Parapet Study and LOI 331

- Background
- Parapet Risk Study
- Proposed changes to NR/L3/CIV/020
- Discussion

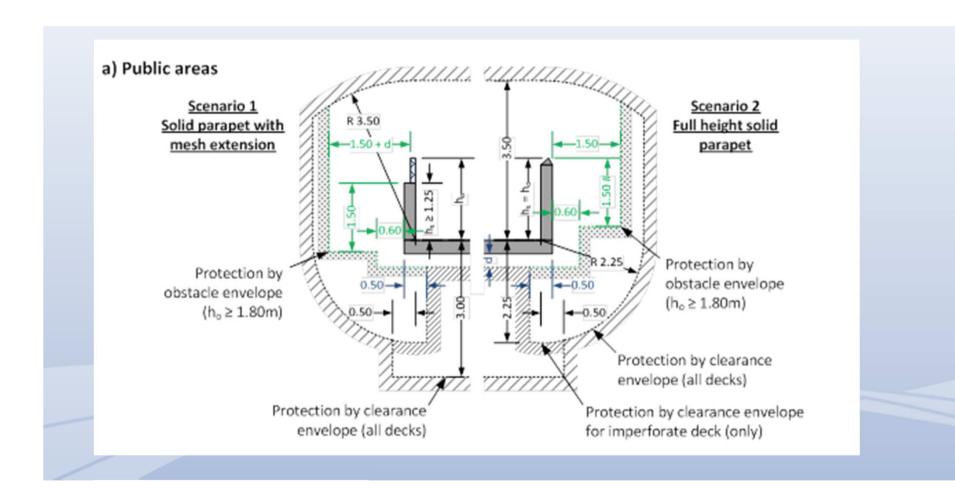
> Increase in minimum height of new parapets over railway

Non-motorway overbridges
 1.5m → 1.8m*

Motorway overbridges1.5m (n/c)

Footbridges1.5m → 1.8m*

Intersection bridges
 1.25m (1.5m over OLE) (n/c)

Any bridge at high risk of T&V / suicide1.8m

* may be reduced to 1.5m in low risk locations

- Requirements for new or existing parapets over new or upgraded OLE:
- where protection provided by clearance
 - Protection by clearance envelope (solid decks) $3.0m \rightarrow 2.25m$
 - Motorway bridges considered as 'public area' clarification
- where protection provided by obstacle
 - Protection by lateral obstacle
 - Overbridges / footbridges over OLE
 - Underline / intersection bridge over OLE
 - All bridges where OLE adjacent to parapet
 - Lateral clearances where OLE adjacent to parapet some increases

departure required

1.8m (n/c)

1.5m (n/c)

1.8m (n/c)
